See-through schematic of proposed extention over a photograph of the existing structure

Points of concern and objections to the proposed extention of 340 Upper Shoreham Road shown above

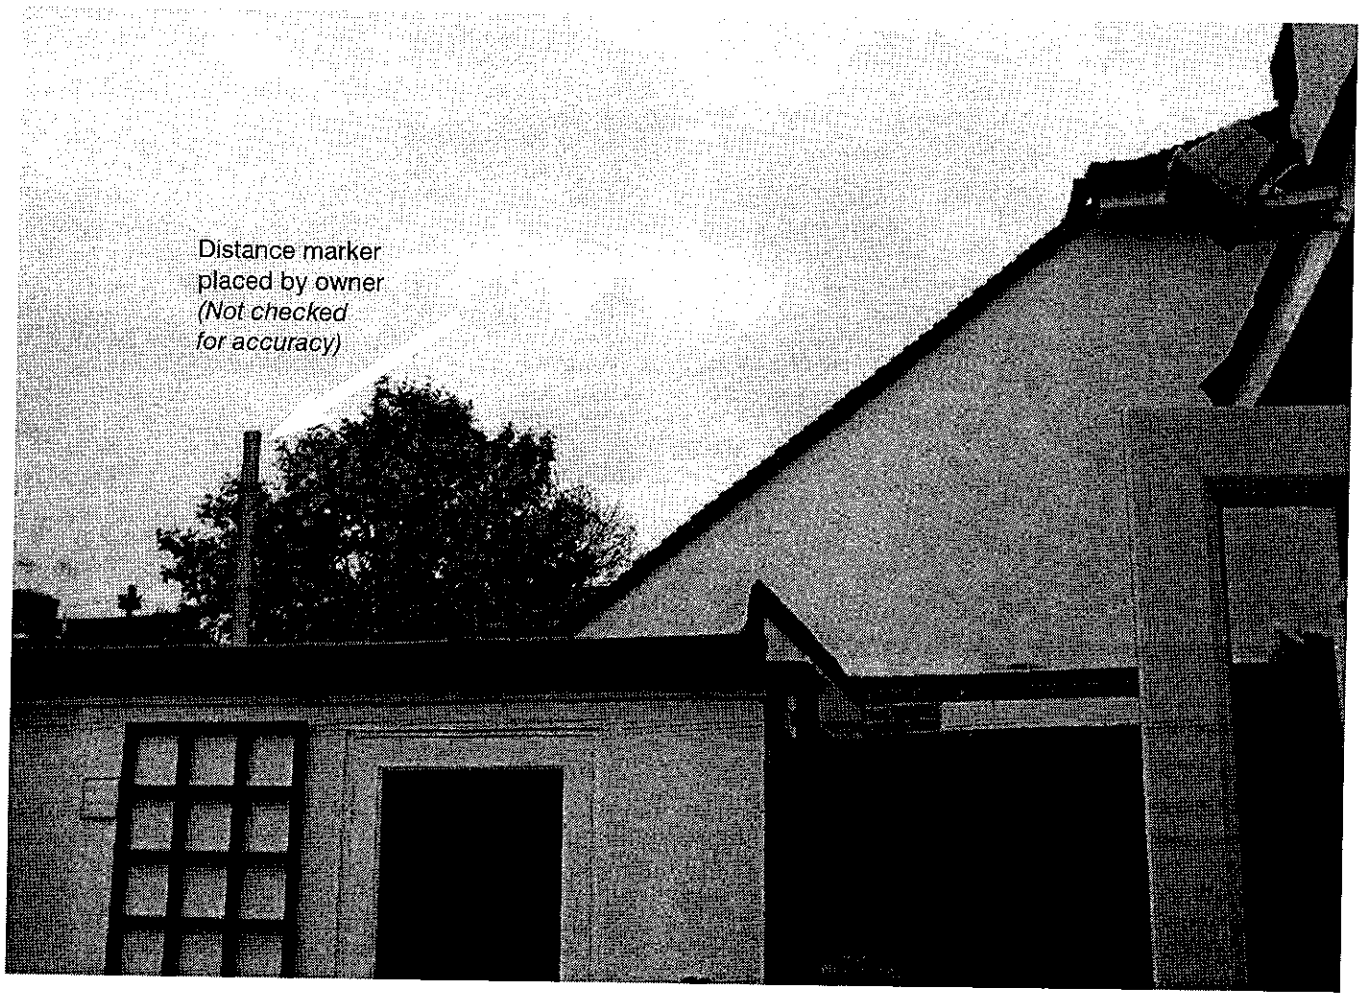
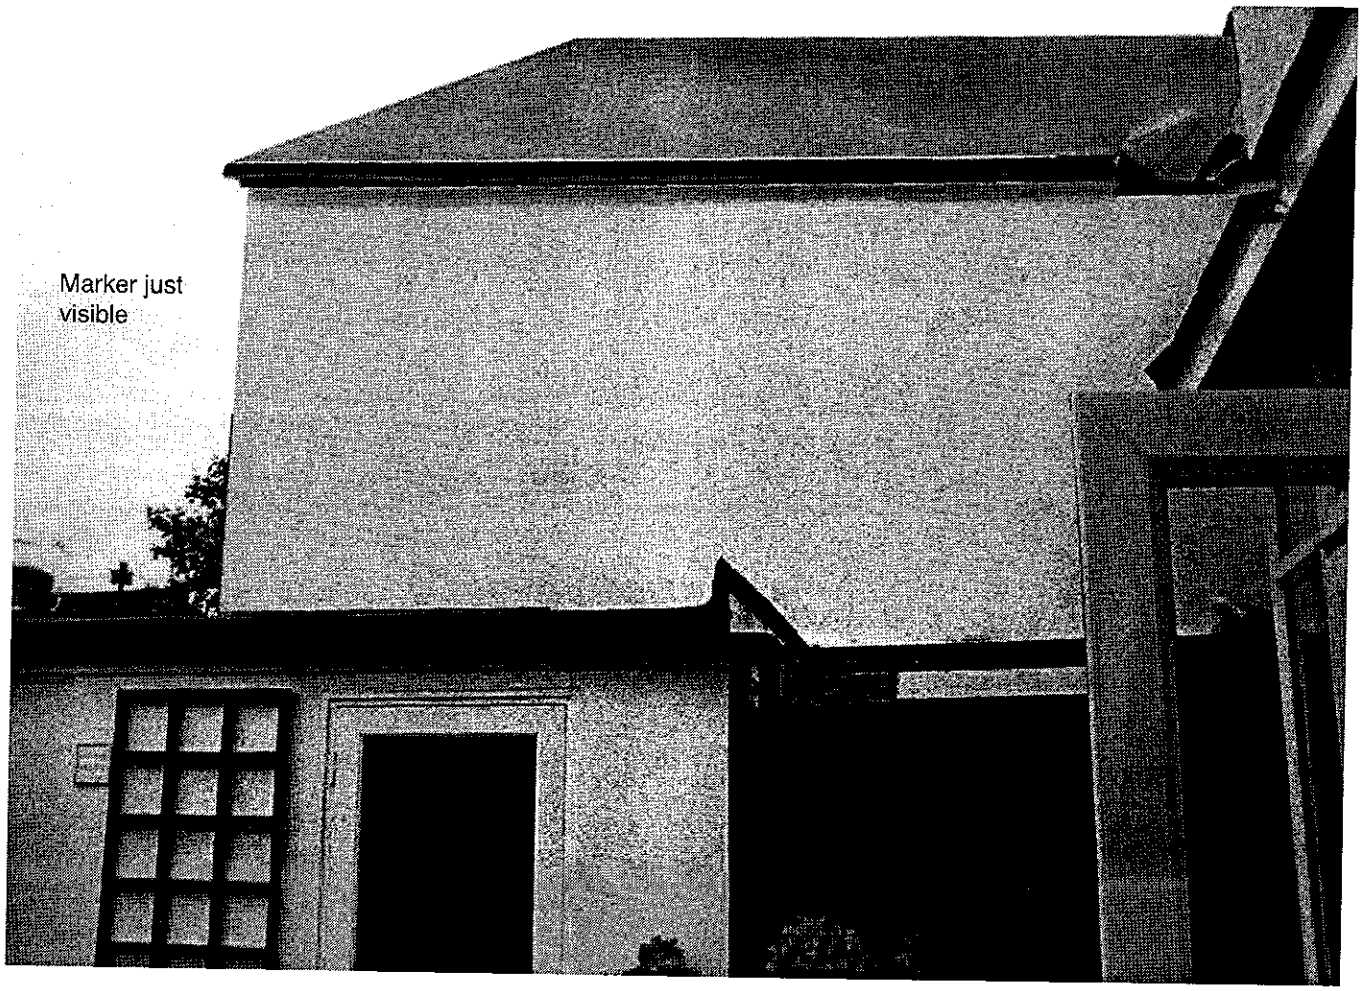
Distance marker
placed by owner
*(Not checked
for accuracy)*

Marker just
visible

Viewed face on
the new build would
extend up to this
broken rule

- The proposed development will extend 5.5 metres from the north face of 342 Upper Shoreham Road.
- 340 Upper Shoreham Road is only 1 meter at most from 342 boundary.
- Extention will be overbearing, visually obtrusive and light restricting.
- Proposed plan exceeds the un-written 45 degree rule by some 35 to 40%.
- Bedroom window will overlook 342 garden (at present there is none).
